National Electrical Safety Code
Interpretations
1988—1990 inclusive

National Electrical Safety Code Committee, ANSI C2

Abstract: This edition includes official interpretations of the National Electrical Safety Code as made by the Interpretations Subcommittee of the National Electrical Safety Code Committee, ANSI C2.

Fig IR 407-1

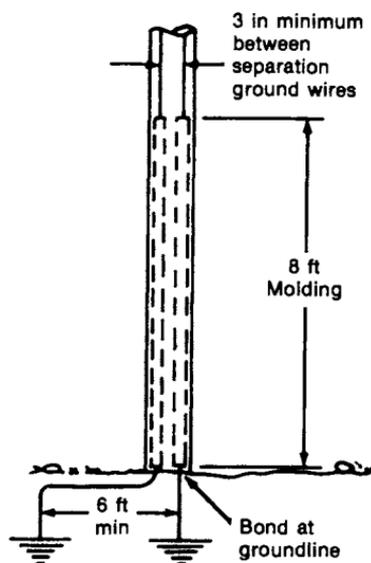
(a) Where full control of access is exercised (freeways, interstate highways with no at-grade crossings or driveway connections).

(b) Where partial control of access is exercised (state highways and some county roads where selected at-grade crossings and driveway connections are allowed).

Fig IR 422-1

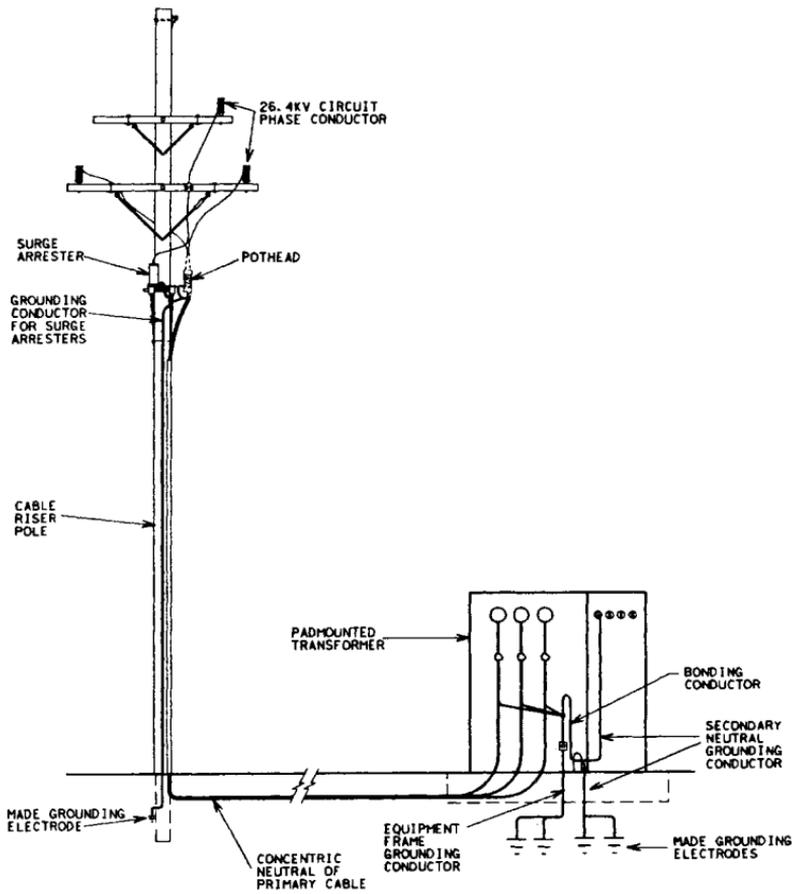
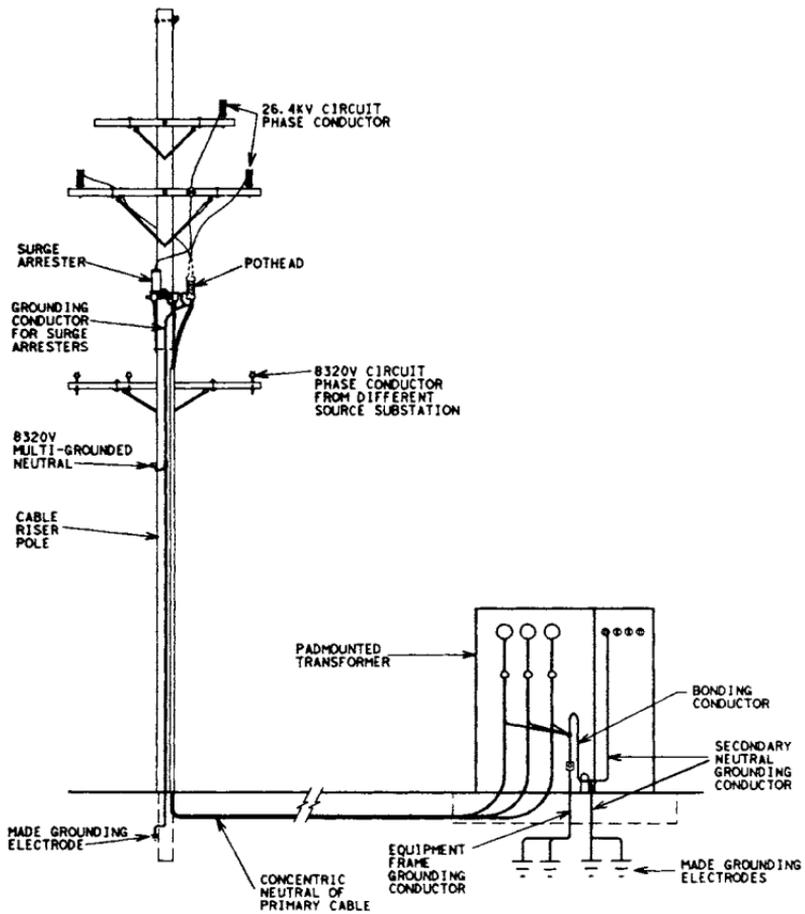
Does your interpretation change if the second circuit is of the same primary voltage (26.4 kV) but, again, from a different source substation? We feel this should not make a difference.

We have come to our interpretation based on our review of the history of this Rule, which is included as Attachment A. Please review these questions and provide an interpretation.

Question 1. The surge arrester ground and frame ground of Question 1 are both included within Class I of Rule 97A and may, therefore, be interconnected.

Question 2. No. See IR 420 and Question 4 of IR 407. The requirements of Rules 97B and 97C are *not* met.

Question 3. Yes. The wording of Rule 97B does not specify that the primary neutral must be of the same circuit as that feeding the secondary circuit to be grounded.

Question 4. The interpretation does not change.

Fig IR 427-1

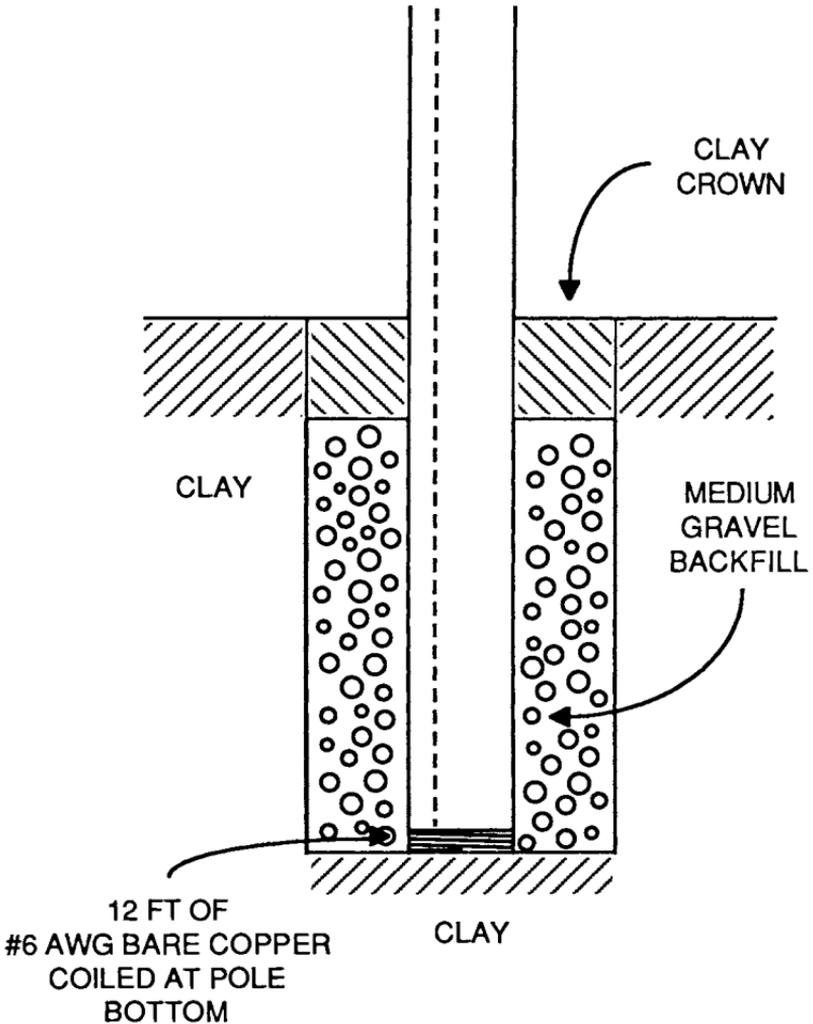
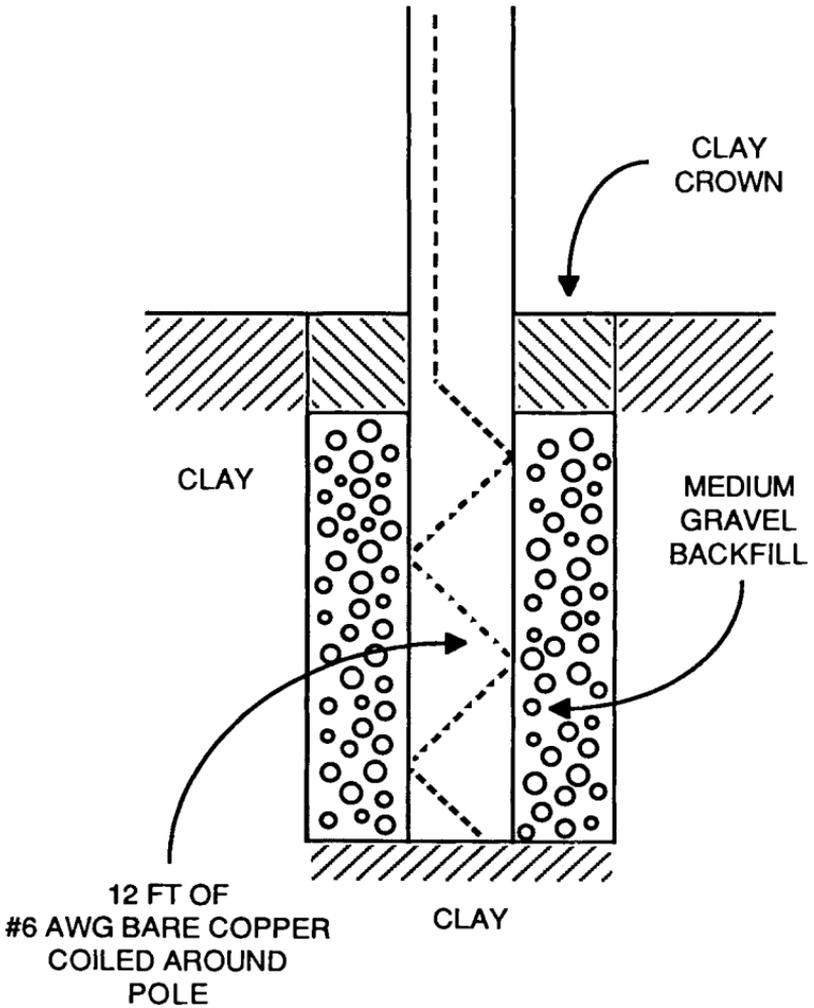
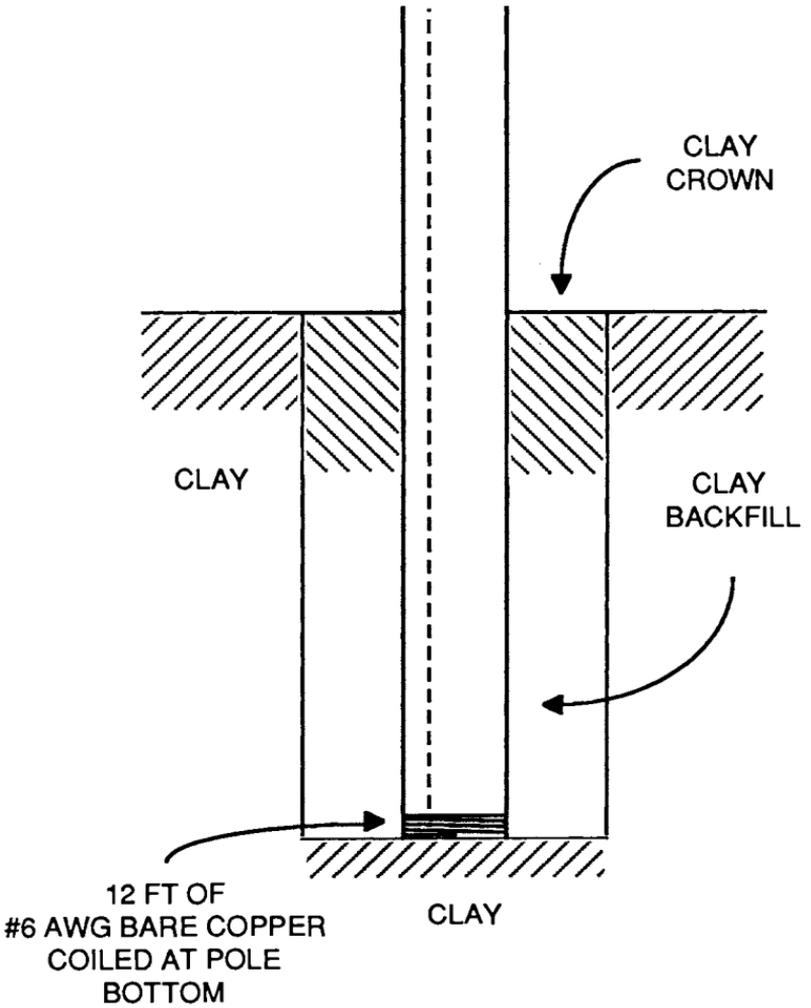
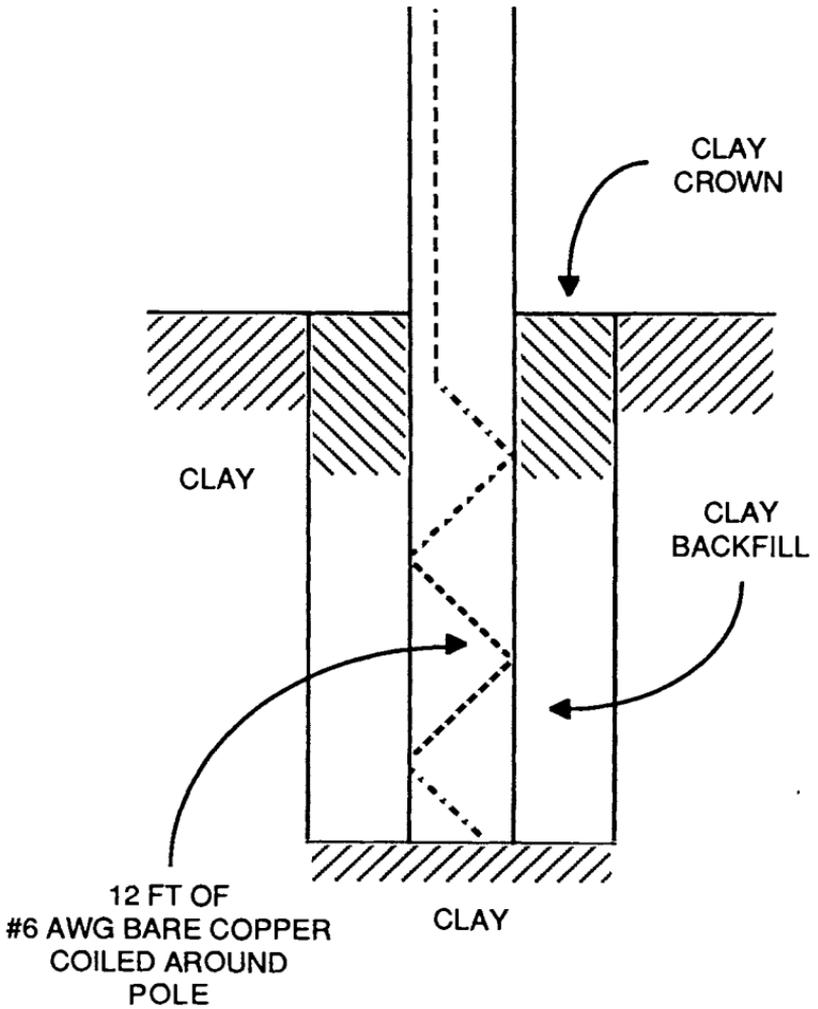
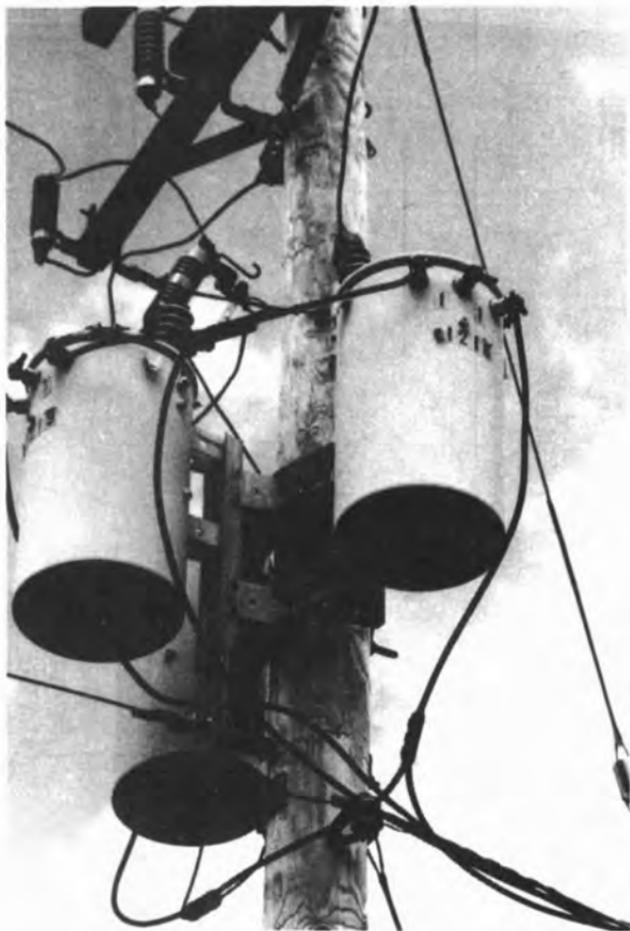
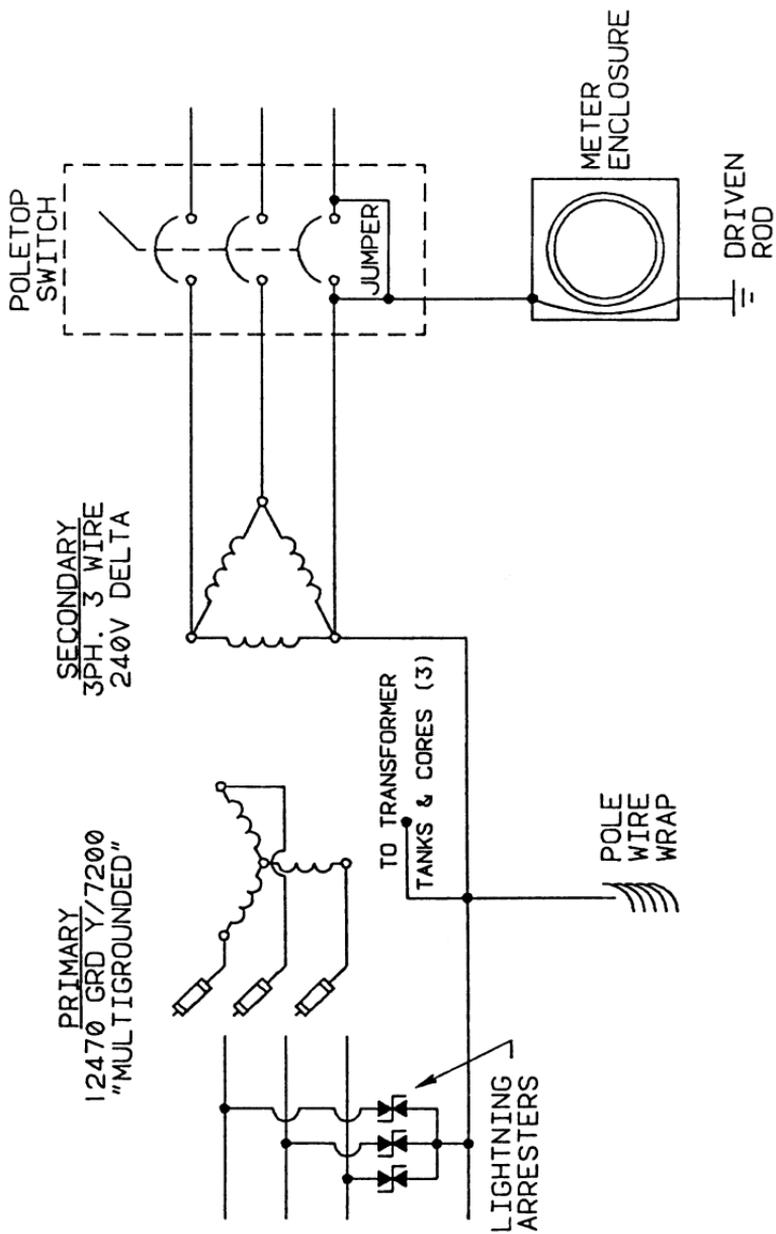
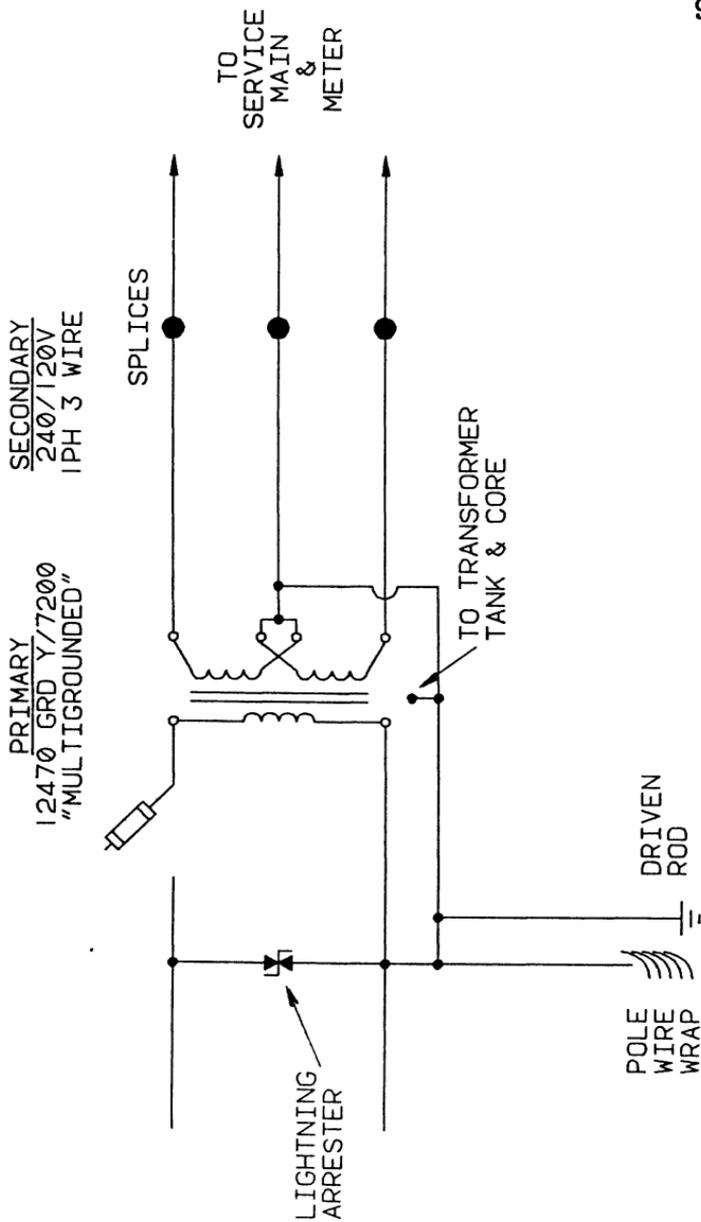
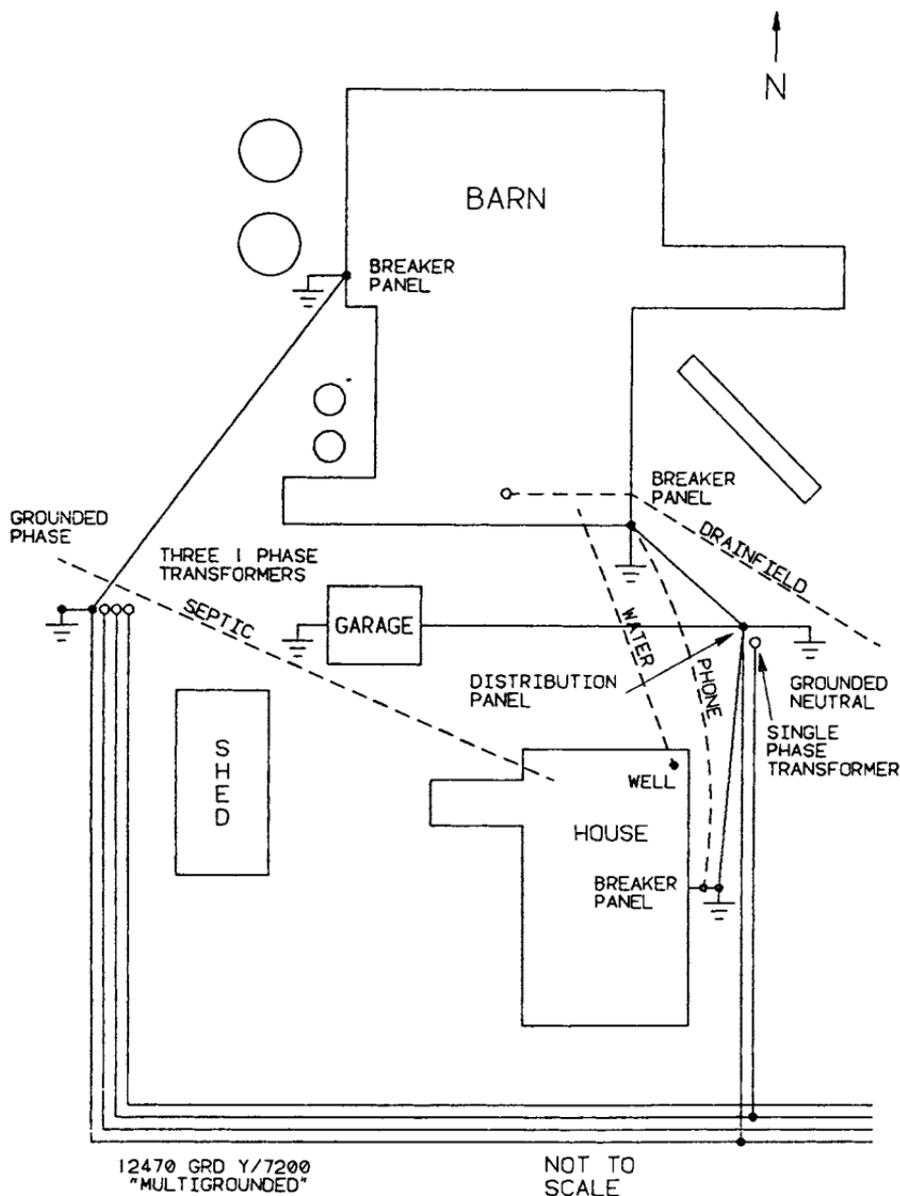
I am requesting your assistance in interpreting the NESC compliance of both the described distribution transformer installation, and the installation of the multigrounded distribution neutral. Figs IR 427-1 to IR 427-6 show the transformer installation in question, a schematic of this transformer installation, a sketch of the location of the three-phase and single-phase services in relation to the buildings, and a sketch of distribution pole installations.

Question 1: Can a corner-grounded Delta secondary conductor be considered a neutral under 97A? If so, can interconnection of this grounded corner with the primary neutral comply with Rule 97B?

Question 2: Does the "jumper" at the three-phase service main comply with 92B1, which states, "grounding connections shall be made at the source, and at the line side of all service equipment...?"

Question 3: The established multigrounded distribution system consists of pole wire wraps in a geographic area with topsoil predominantly mixed with sand, and a subsoil ranging from sand to gravel. A recently (June, 1988) relocated section of 12470Y/7200 distribution system, of approximately six miles in length, was installed in one of the few "pockets" of low

resistivity soil (clay). The method of construction was to place the pole, with wire wrap, into a drilled hole, backfill the hole with medium gravel, and then crown the top of the hole with clay. Can this be considered effectively grounded, using the NESC definition?

Question 1. A grounded phase conductor cannot be considered a neutral conductor; it is a grounded secondary phase conductor. See the definitions of “neutral conductor” and “grounding conductor” in IEEE Std 100-1988, IEEE Standard Dictionary of Electrical and Electronics Terms. See also IR 234.

In addition, the grounded secondary phase conductor is not a secondary neutral and does not qualify under the wording of Rule 97B2. Lastly, the primary neutral may not meet Rule 97C; see the comments under Question 3.

Question 2. The jumper at the 3-phase service entrance appears to meet the requirements of Rule 92B1. We point out that, if the service entrance panel is on the pole with the poletop switch, one ground rod is appropriate; if the two are at different locations, an additional ground rod would be needed at the service entrance.

Question 3. You have shown two types of wire wrap (pole wrap and butt coil) and two types of backfill (clay and medium gravel). The butt-coil wire wraps of Figs IR 427-1 and IR 427-3 are functionally equivalent to a pole butt plate and meet the requirements of Rules 94B4a and 94B4c if the clay is of low resistance.

Fig IR 440-1
Standard Installation

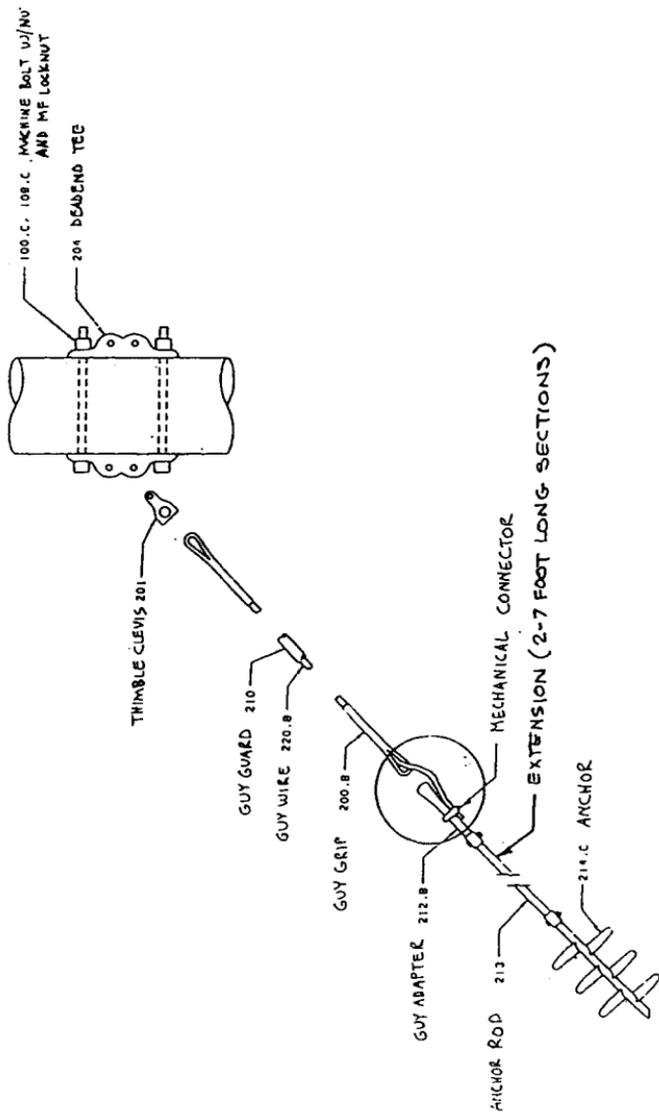
We would appreciate your review of our installation in general and specifically your interpretation of whether the helix anchor meets the requirements of NESC 94B2 as a driven rod made electrode.

Fig IR 428-2

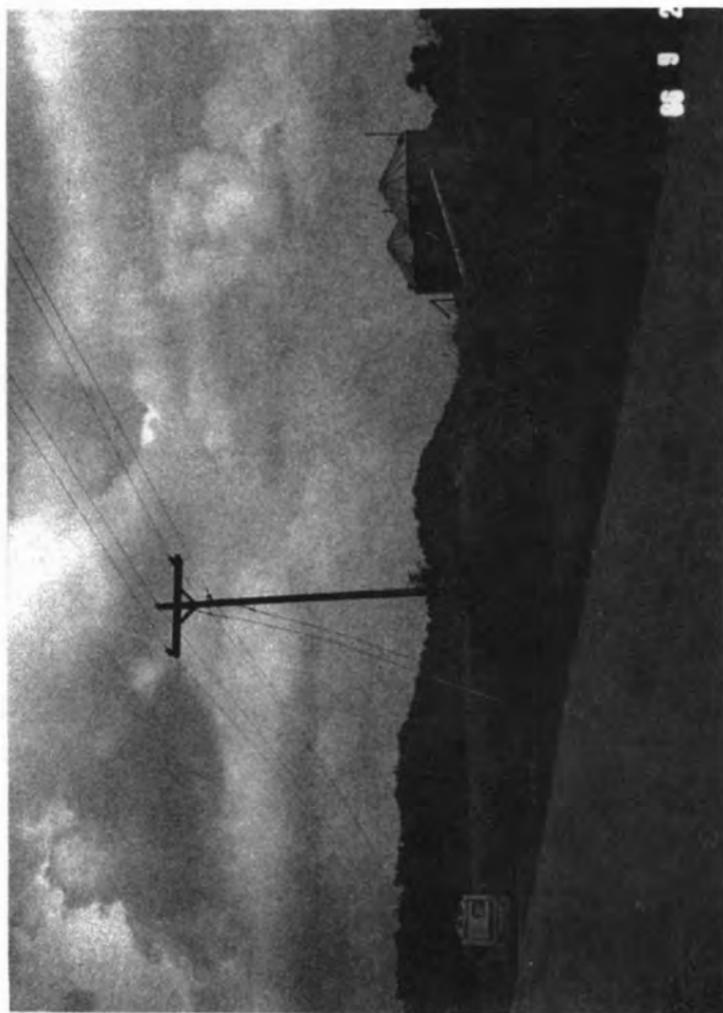
The three-phase line, at one particular point, crosses over a gravel driveway that runs from the county road to some grain bins. Figs IR 428-1 to IR 428-3 show pictures of the area. The gravel driveway is subject to truck traffic and, of course, various farm equipment.

The co-op requests that the committee provide us with an interpretation of Table 232-1 as it relates to this situation. If there is any further information you need, please notify me and I will immediately supply you with that information. Thank you for your assistance.
